Access Compliance Report

Public Rights-of-Way

(Pedestrian Signals)

Intersection ID: N/A	Main Street:	Cross Street: N/A	Location: N/A
ADA ID: D43B46ACA40C	Signal Type: One Push Button-Non APS	Overall Compliance: No	Severity Score: BTN 1: N/A BTN 2: N/A No BTN: N/A
Codes/Mitigation Info/Possible Solution		Field Measurements/Component Compliance

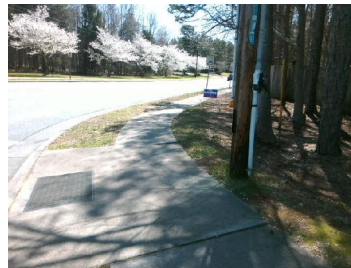
N/A	B 1 Clear Xing Direction?	Yes	N/A	B 2 Clear Xing Direction?	N/A
	B 1 Crossing Direction	To NW		B 2 Crossing Direction	N/A
No	B 1 DistanceTo XWalk (in)	107.0	N/A	B 2 DistanceTo XWalk (in)	N/A
No	B 1 DistanceTo Curb (in)	107.0	N/A	B 2 DistanceTo Curb (in)	N/A
Yes	B 1 Diameter (in)	2.0	N/A	B 2 Diameter (in)	N/A

Is Button 1 APS or Non-APS?	NonAPS	Is Button 2 APS or Non-APS?	N/A
N/A B 1 VibroTact Arrow?	N/A	N/A B 2 VibroTact Arrow?	N/A
N/A B 1 VibroTact Parallel to Xing?	N/A	N/A B 2 VibroTact Parallel to Xing?	N/A
N/A B 1 VibroTact Contrast	N/A	N/A B 2 VibroTact Contrast	N/A
N/A B 1 Pilot Light?	N/A	N/A B 2 Pilot Light?	N/A
N/A B 1 Pilot Light Illumination?	N/A	N/A B 2 Pilot Light Illumination?	N/A
N/A B 1 Verbal Walk Cycle?	N/A	N/A B 2 Verbal Walk Cycle?	N/A
N/A B 1 Verbal Message Audible?	N/A	N/A B 2 Verbal Message Audible?	N/A
N/A B 1 Locator Tone?	N/A	N/A B 2 Locator Tone?	N/A
N/A B 1 Percussive Walk Cycle?	N/A	N/A B 2 Percussive Walk Cycle?	N/A
N/A B 1 Extended Press Feature?	N/A	N/A B 2 Extended Press Feature?	N/A
N/A B 1 Tone Audible Range?	N/A	N/A B 2 Tone Audible Range?	N/A

Possible Solutions: Replace Signal Push Button With APS Button on New Post. Remove & Relocate Sign.

PROW/ADA: TMUTCD 4e.08, R404.3, R404.2, R404.7.2
